CITY OF ALBUQUERQUE

RE: 1459 Valle Lane. NW
Grading and Drainage Plan
Engineer's Stamp Date: 06/28/20
Hydrology File: G13D039

ENGINEER'S SEAL	LOT 38-P1 CANDELARIA VILLAGE 1459 VALLE LANE, N.W.	DRAWN BY DEM
DAVID SOULE 14522 PROFESSIONAL ENGINEER	GRADING AND DRAINAGE PLAN	DATE 6-27-20
6/28/20	Rio Grande Engineering 1608 CENTRAL AVENUE SE SUITE 201 ALBUQUERQUE, NM 87106 (505) 972-0899	LOT 38-P1 CANDELARIA VILLAGE DWG
		SHEET # C1
		JOB #

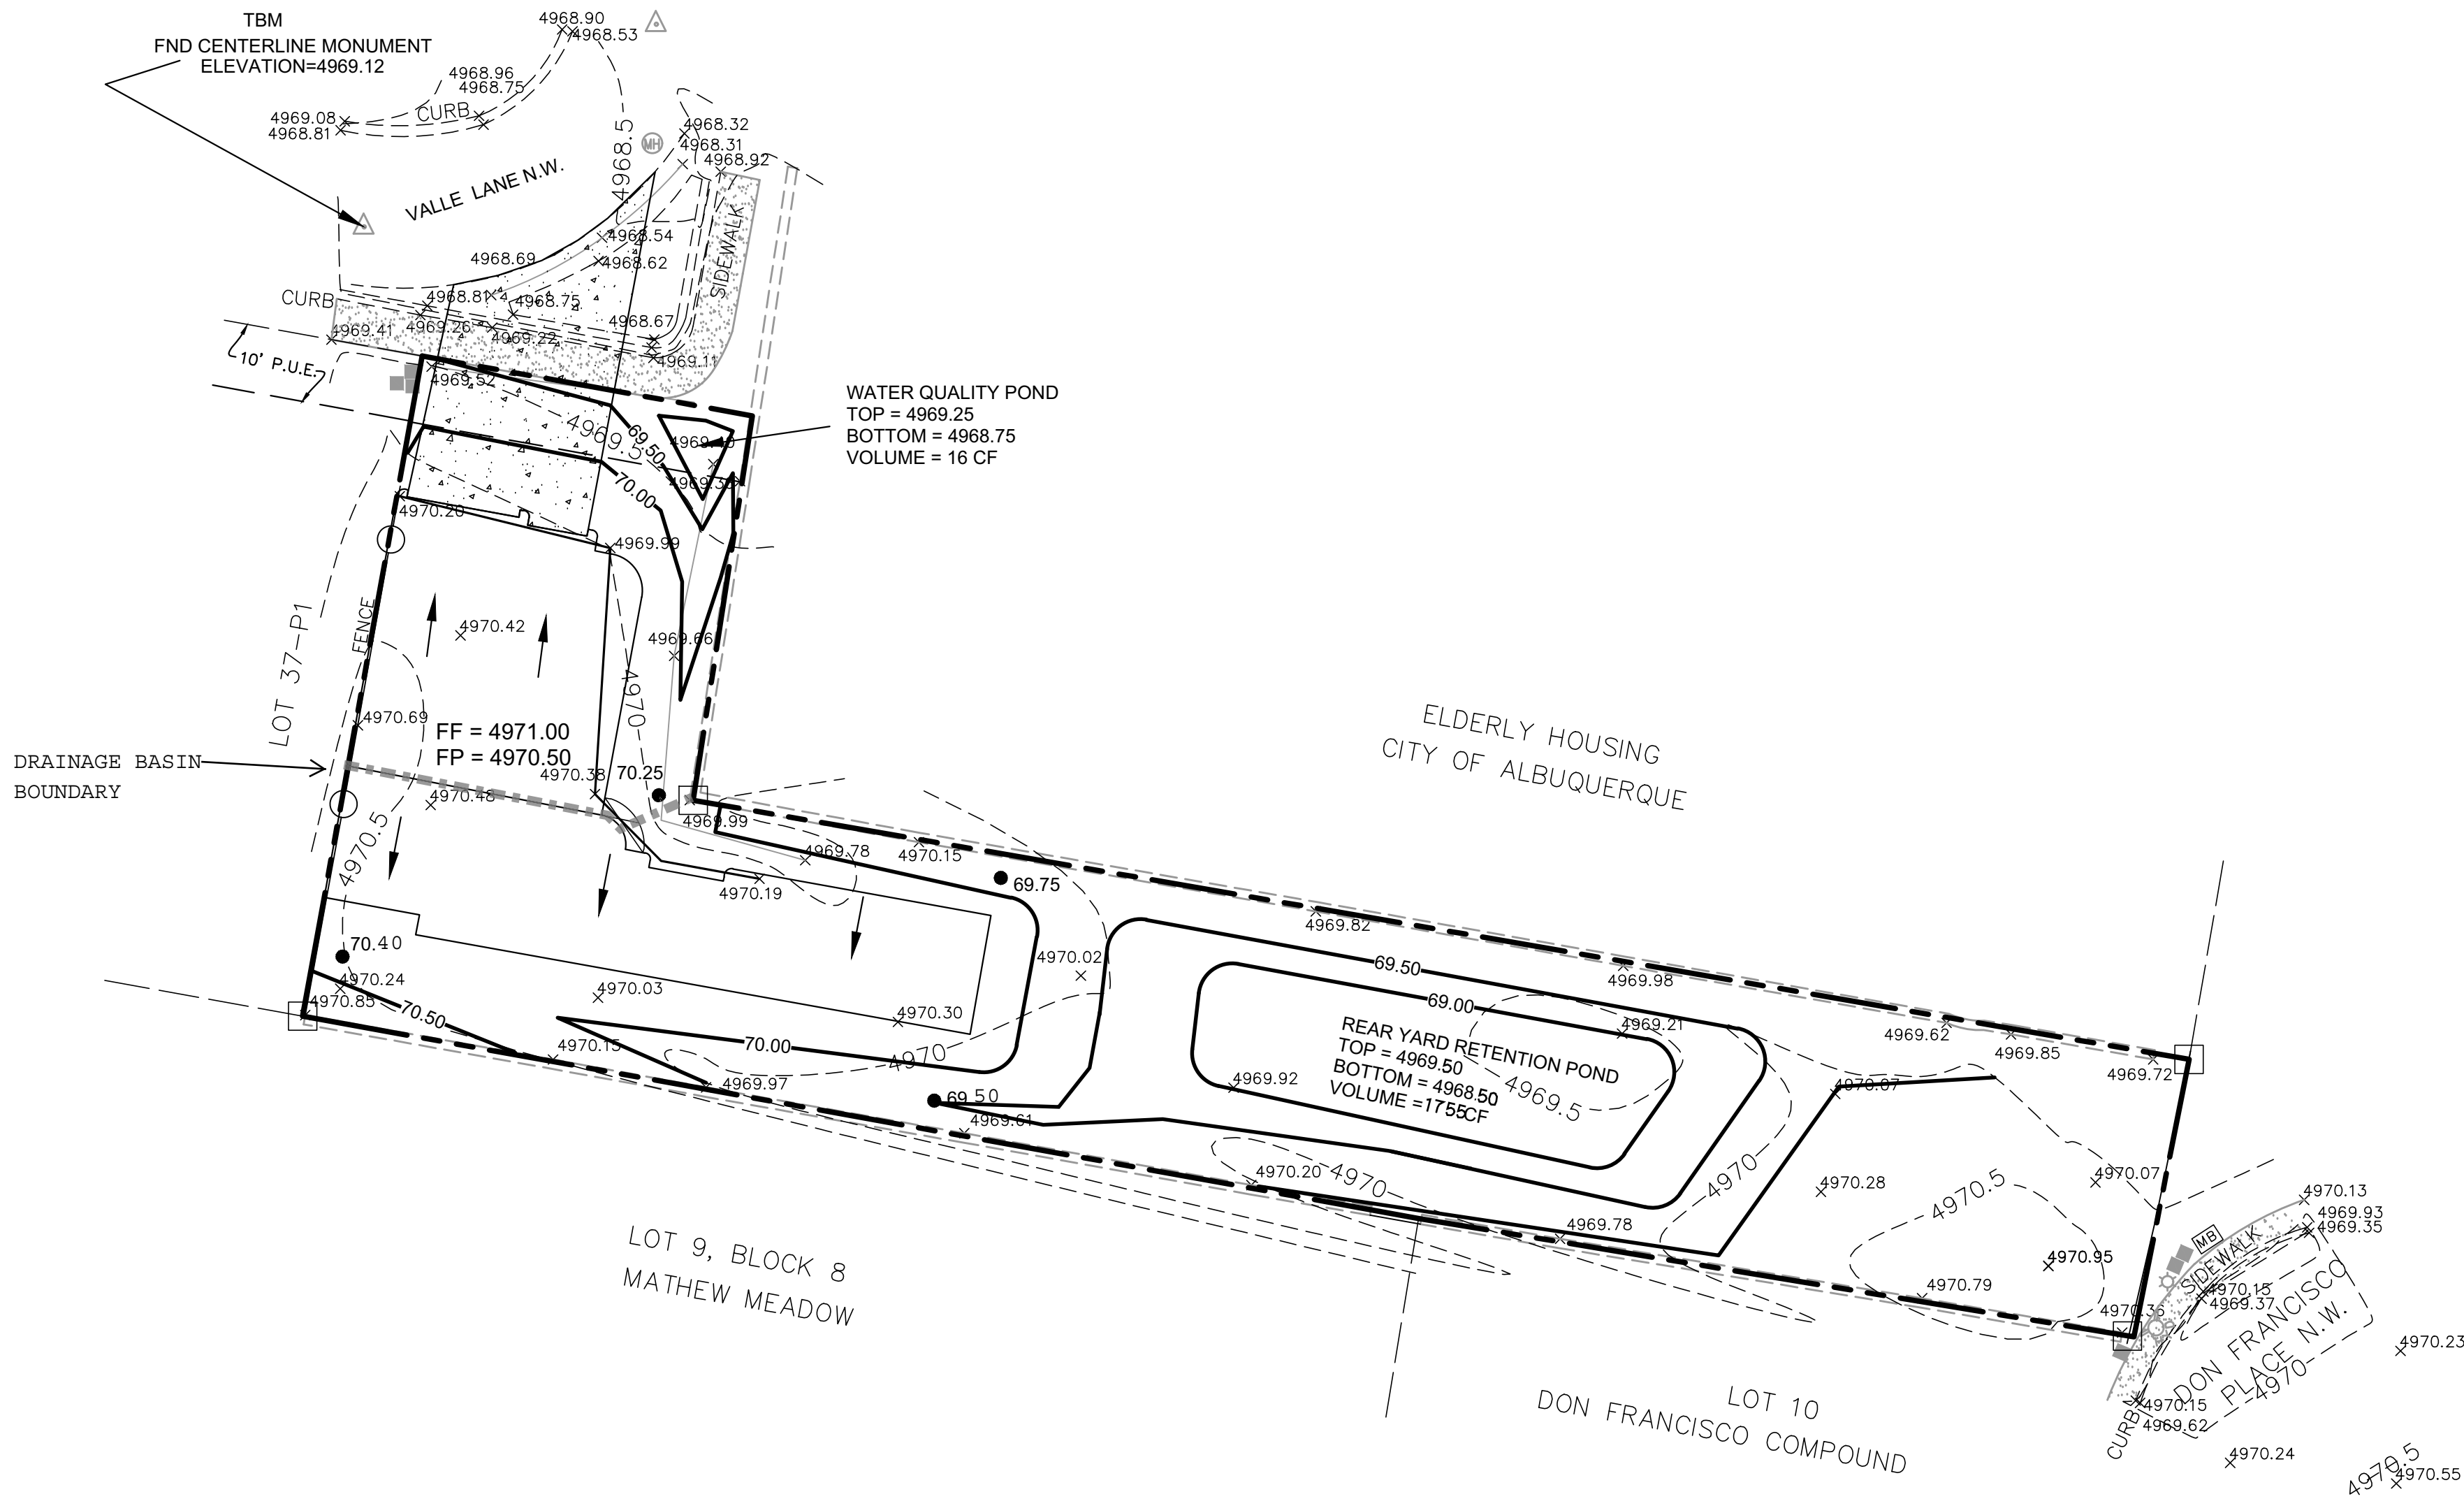
Based upon the information provided in your submittal received 06/29/20, the Grading and Drainage Plan is approved for Building Permit.

Once the grading is complete, a pad certification will be required prior to release of Building Permit. Please attach a copy of this approved plan in the construction sets for Building Permit processing along with a copy of this letter and the pad certification approval letter.

Prior to approval in support of Permanent Release of Occupancy by Hydrology, Engineer Certification per the DPM checklist will be required.
